SPECIALIST CONSULTANCY SERVICES AT HDB DEVELOPMENT (WESTERN)

Tengah North EMMP Consolidated Addendum (Area A)

Housing & Development Board (HDB)

Date: 4 November 2024

Figure 2-1 RAC Reduction in Area A & Site Clearance and Earthworks Phase 5

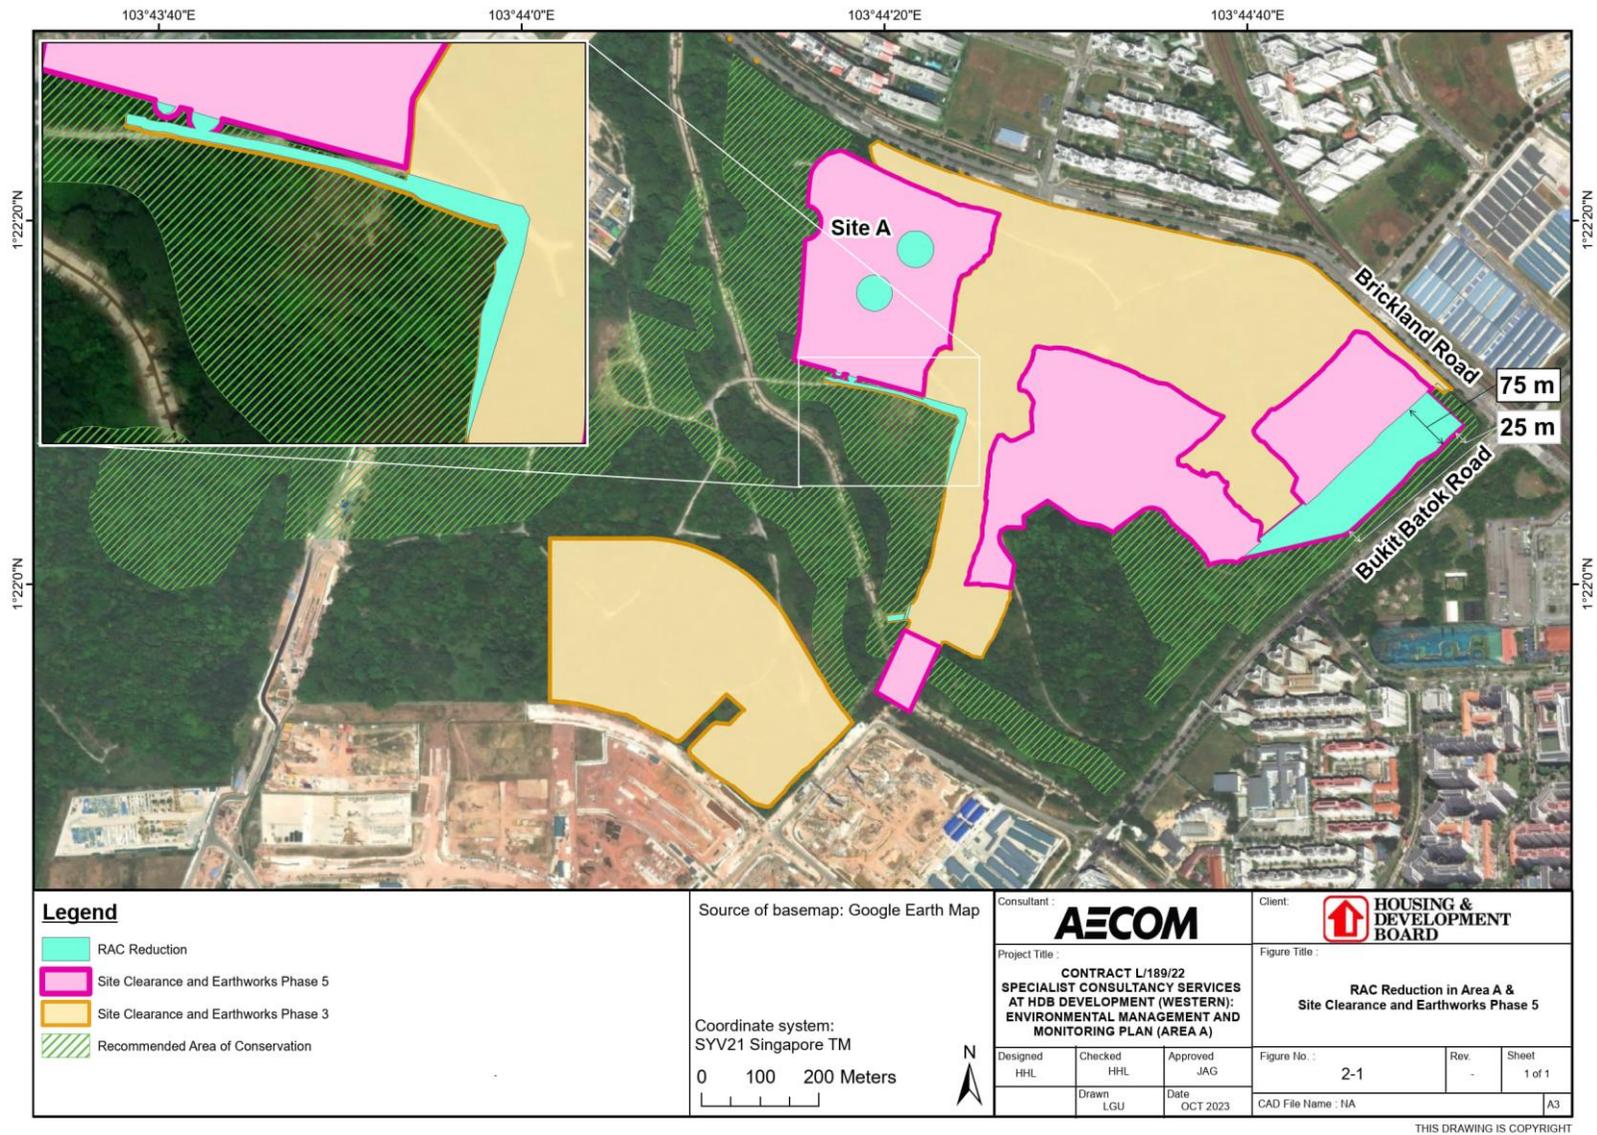
Based on interagency discussions and engagement with stake holders (i.e., Nature Groups) on Tengah North Land Use following the publication of the Tengah North EIS on 5 Nov 2021, the presence of the corridor may instead attract wildlife to the junction of Brickland Road and Bukit Batok Road, and as there are difficulties ensuring wildlife connectivity across the major road junction, this could increase incidences of roadkill in that area as there is no feasible crossing. It was therefore agreed, in consultation with stakeholders, that the RAC along Bukit Batok Road should be tapered from 100m to a 25m-wide Forest Fringe [R-2] instead to funnel wildlife towards a wildlife crossing across Bukit Batok Road along Bukit Batok West Avenue 7 instead.

The RAC within Site A is also not to be retained. Prior to any site clearance, if bamboo bats are detected in the affected bamboo clusters, they will be translocated to another location with suitable receptor bamboo clusters that is agreed on with NParks. There are also 3 small areas of reductions of RAC due to updated development plot.

This is a deviation to the RAC presented in Section 2.5 of the approved EMMP Report Area A. Kindly refer to Figure 2-1 on the change of RAC described above.

Figure 2-2 Overview of Affected Habitats

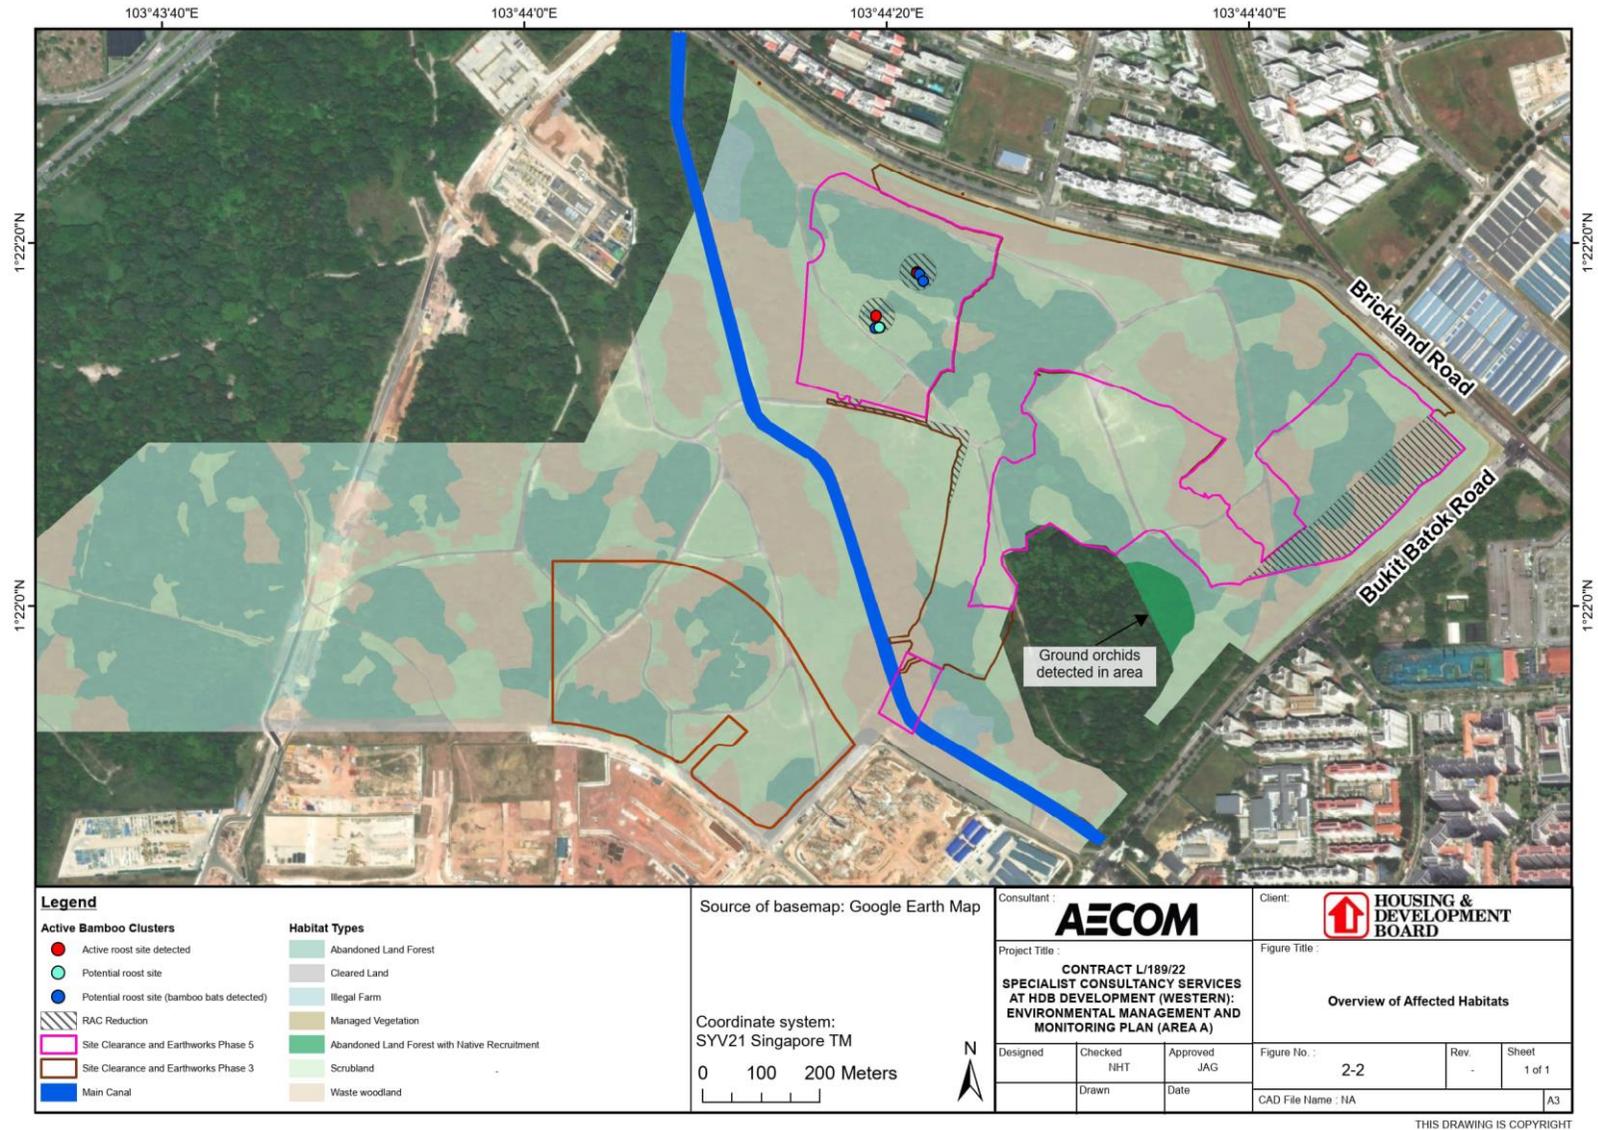
The affected habitats are summarised in Table 2-1 and Figure 2-2. Specific receptors that may be impacted or are close to affected areas include:

Location of RAC	Reason for Removal	Habitat Type Lost	Area (ha)	Specific sensitive receptors
Within Site A	Platform level changes are required for the future development, and retaining the platform levels within the RAC limits the ability to optimise the development.	Abandoned land forest	0.375	Eight bamboo clusters will be affected, of which bamboo bats (<i>Tylonycteris</i> sp.) were recorded roosting in three of the clusters
		Scrubland	0.221	
RAC along Bukit Batok Road	As the existing proposed RAC is located in proximity to major roads (i.e., junction of Bukit Batok Road and Brickland Road), this forested corridor could result in increased road kill and human-wildlife conflict along the major roads. This is because the corridor may lead to ground-dwelling fauna utilising the area and attempting crossings at the junction. A taper is therefore adopted to discourage fauna from approaching the junction.	Abandoned land forest	0.842	A population of hairy jewel ground orchids (<i>Hetaeria oblongifolia</i>) was detected in the forest patch within the remaining RAC to be retained and is not affected by the reduction

Figure 3-1 Water quality sampling locations in the vicinity of Area A (Revised)

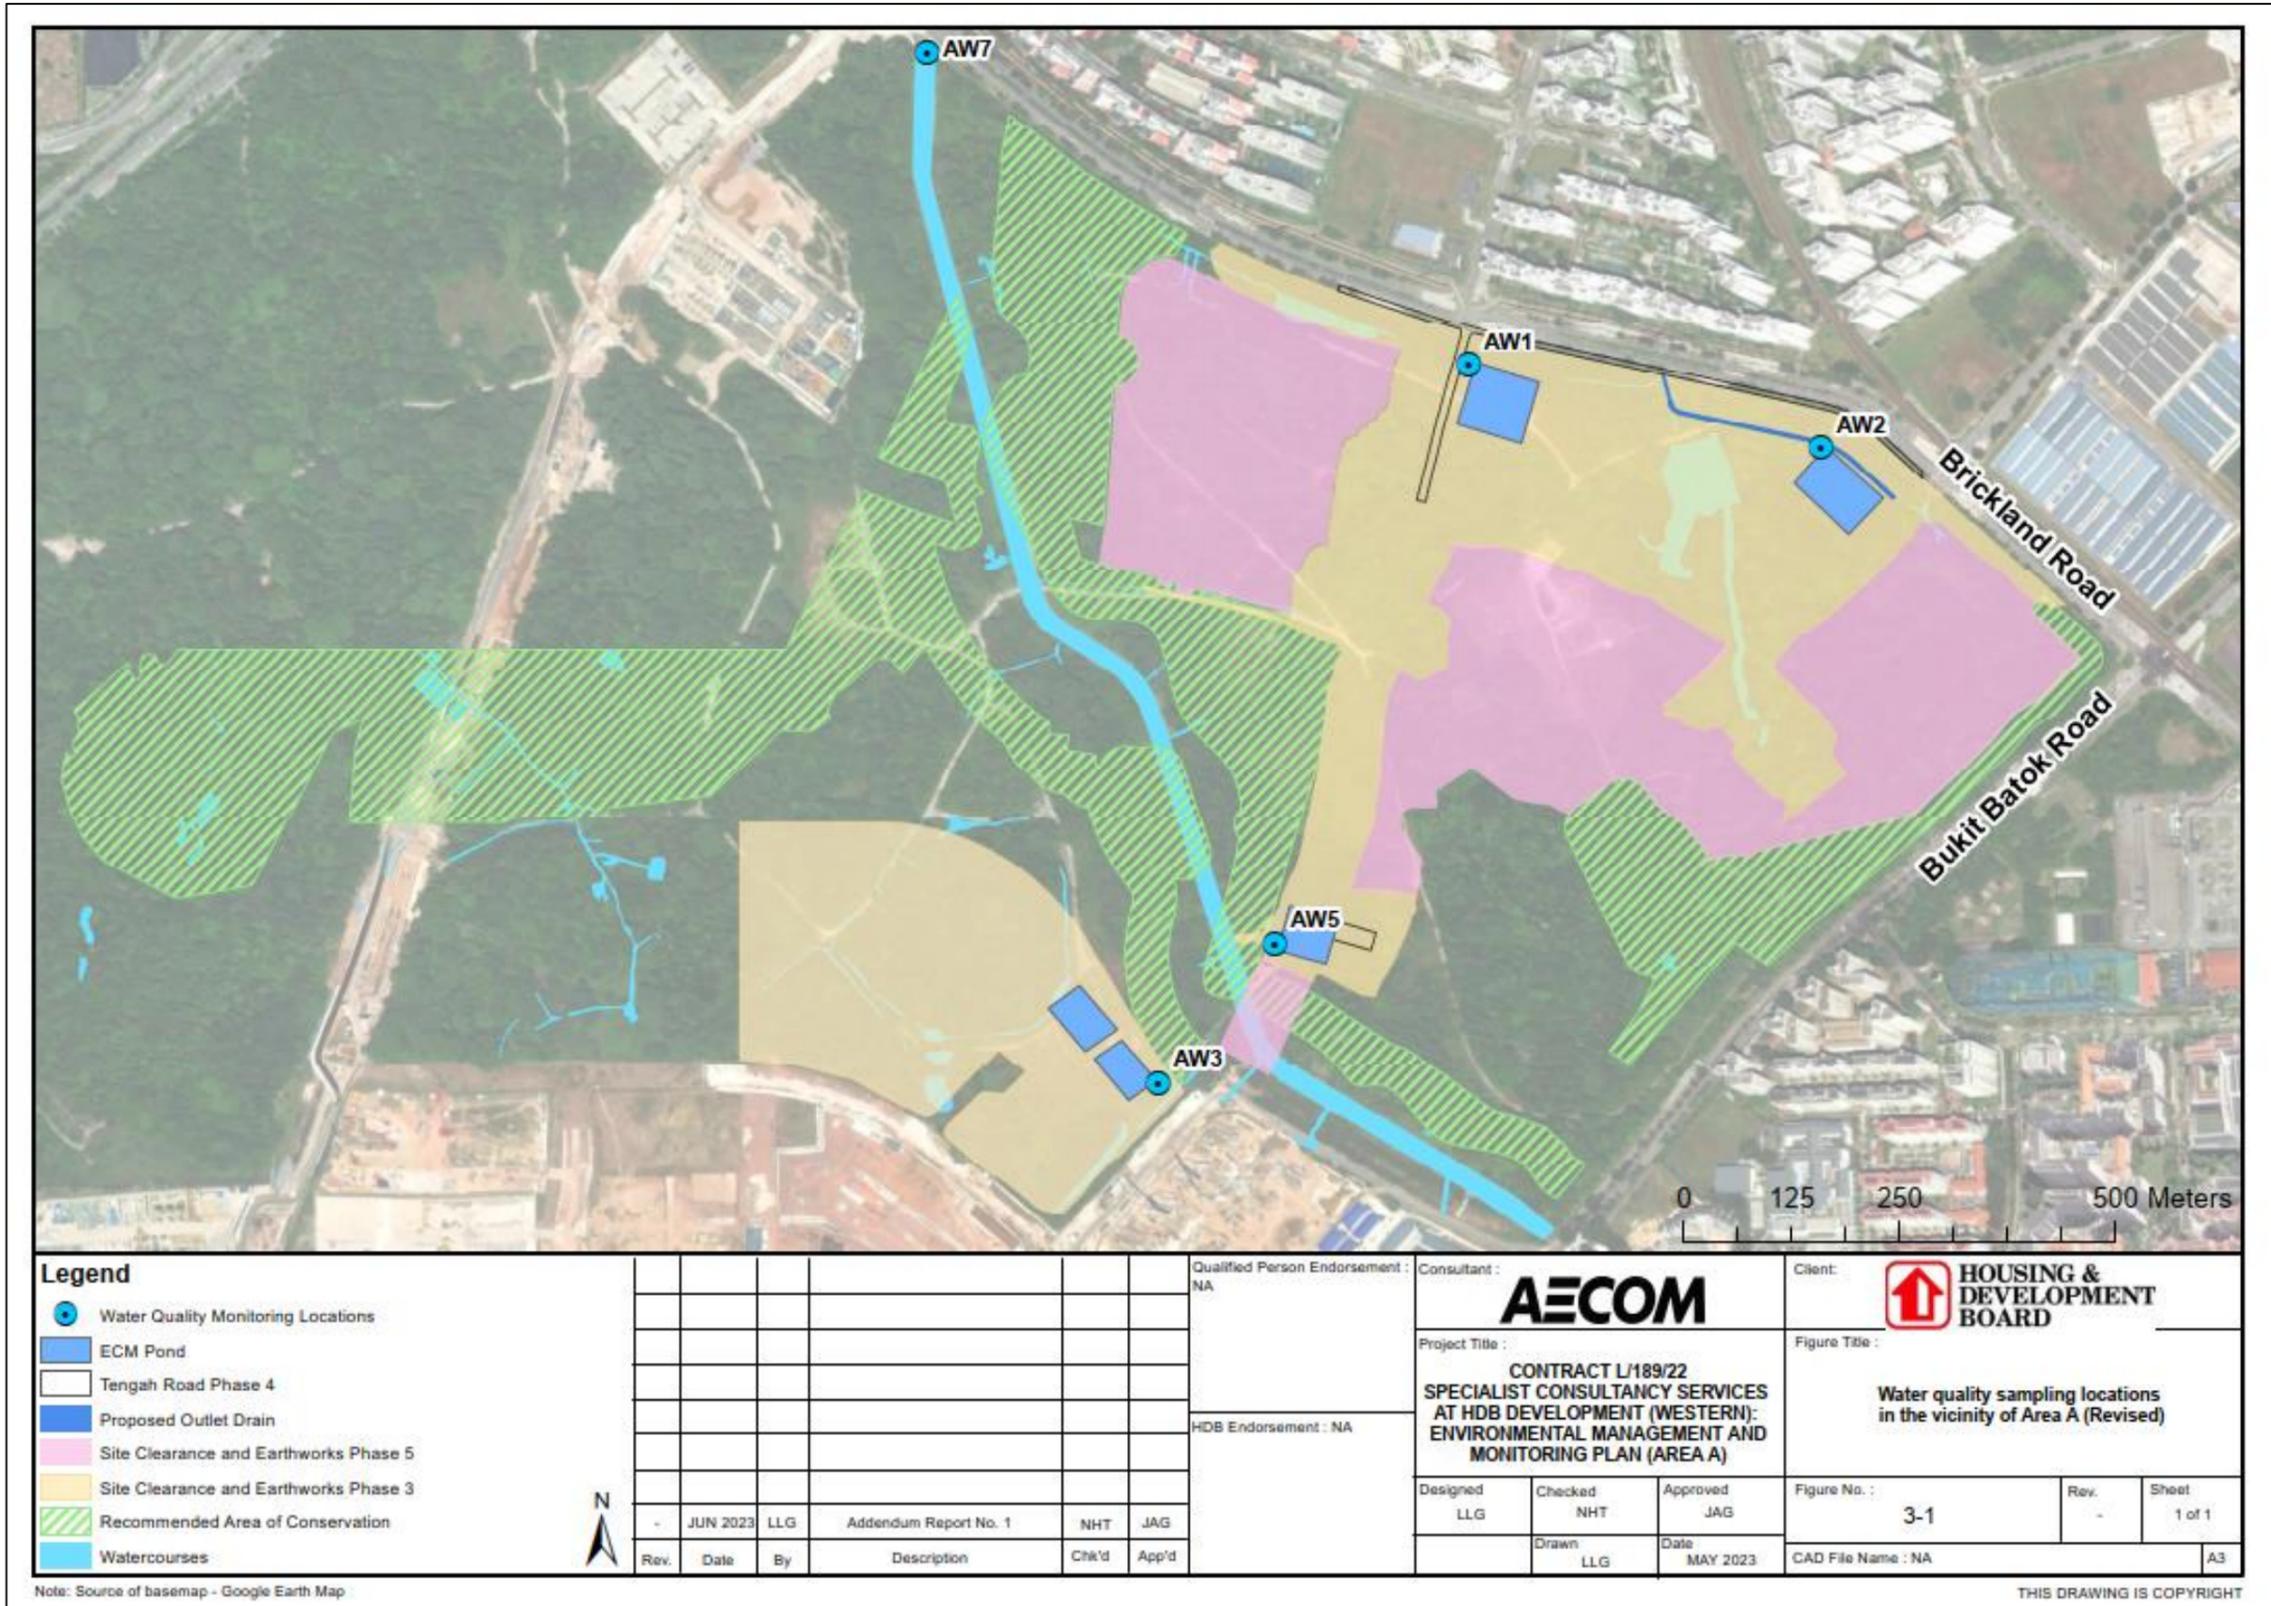
Based on email from PUB on 11 March 2023, the frequency of sampling for heavy metals was adjusted from monthly to quarterly for heavy metals. Sampling for heavy metals is to be conducted for construction discharge outlet only. Also, according to the updated ECM plan, the water quality sampling locations have been revised to monitor the ECM discharge points. The revised plan serves to better represent the necessary water sampling points for this project site.

Five (5) water sampling points (refer to Figure 3-1) were selected within the worksite to assess the water quality of the treated ECM effluent that is being discharged to public drains. All the discharge points from construction worksites should follow the NEA's Allowable Limits for Trade Effluent Discharge to Controlled Watercourse (for all parameters unless otherwise specified here) to assess whether the discharged effluent is in compliance with the regulation [W-1]. In addition, the Singapore's Water Quality Guidelines for Popular Recreational Beaches will be used as a reference for *Enterococcus* only [W-2]. The water quality at selected locations to be sampled in monthly frequency and additional parameters to be sampled quarterly at every construction discharge outlet (refer to revised ECM plan in Appendix A as shown in Table 3-1).

Table 3-2 Comparison of surface water quality sampling locations from Approved EMMP Report and Addendum EMMP Report

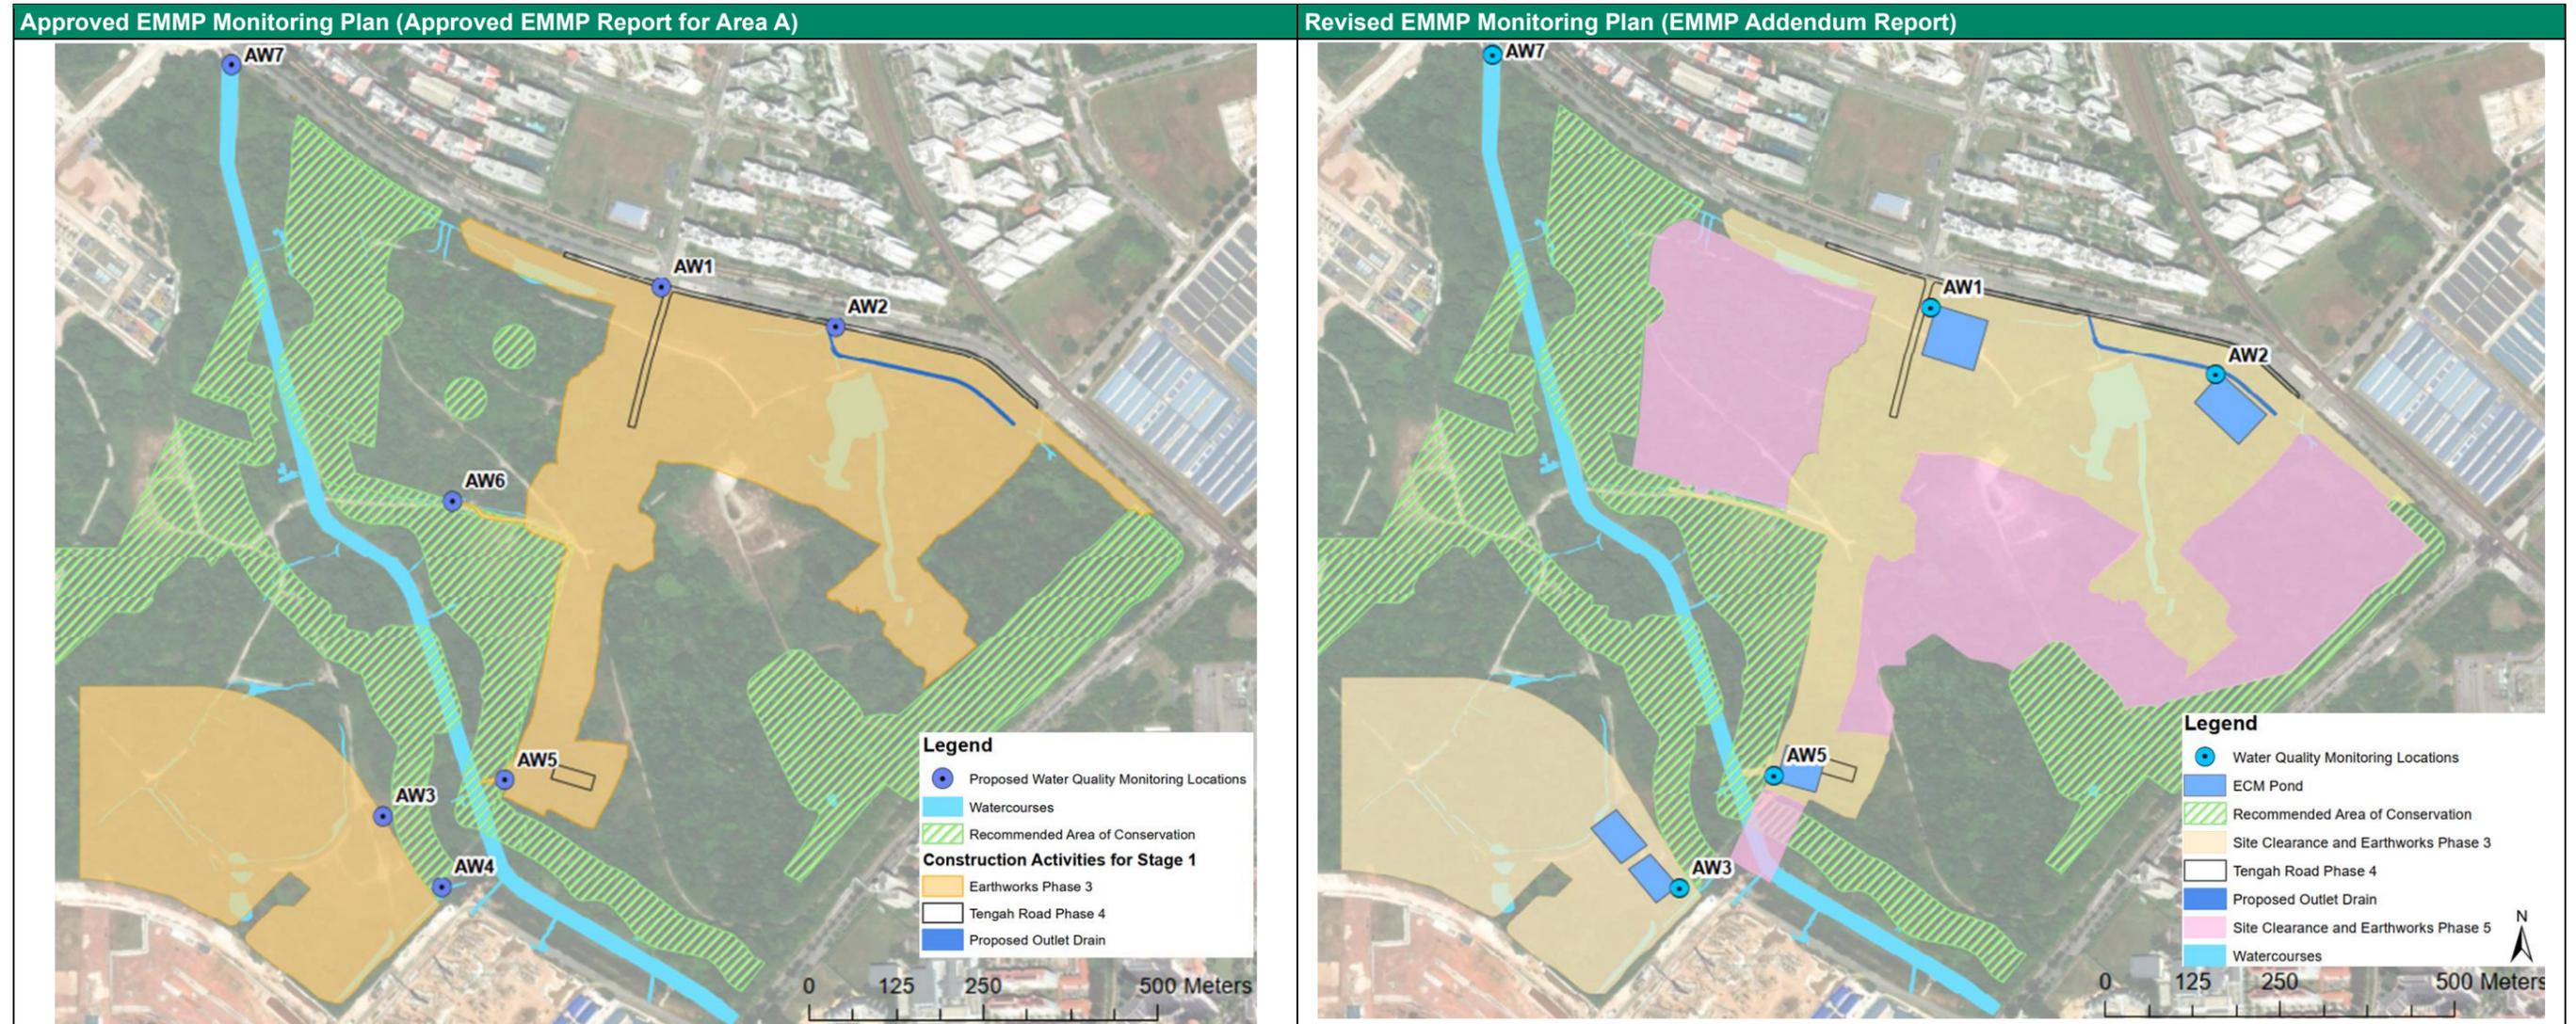
No.	Surface Water Quality Sampling Location	Justification for Revision	Rationale for Selection of Sampling Location
1	AW1	With reference to the hoarding plan [updated as of 2 nd May 2023], there was a change in location of the ECM pond, ECM plant and discharge outlet from the PUB-approved ECM plan. The sampling location will be moved accordingly to sample the discharge from ECM plant.	To monitor the water quality of discharge from the ECM plant
2	AW2	With reference to the on-site ECM provisions and hoarding plan [updated as of 2 nd May 2023], there was a change in location of the ECM pond, ECM plant and discharge outlet from the PUB-approved ECM plan. As the discharge outlet into the public drain is underground and inaccessible, the sampling location was moved to sample the final discharge from the ECM plant accordingly.	To monitor the water quality of discharge from the ECM plant
3	AW3	With reference to the on-site ECM provisions, two (2) ECM ponds are connected by a pipe, and the treated discharge from the ECM plants is currently discharged through a single discharge outlet. AW3 and AW4 are now considered as a single sampling location, AW3.	To monitor the water quality of discharge from the ECM plant

4	AW4		
5	AW5	No revision from approved EMMP Report.	To monitor the water quality of discharge from the ECM plant
6	AW6	The planned outlet drain was removed from the PUB-approved ECM plan (Appendix A). As such, the sampling location was removed accordingly.	-
7	AW7	No revision from approved EMMP Report.	To monitor the water quality downstream of canal as requested by PUB.
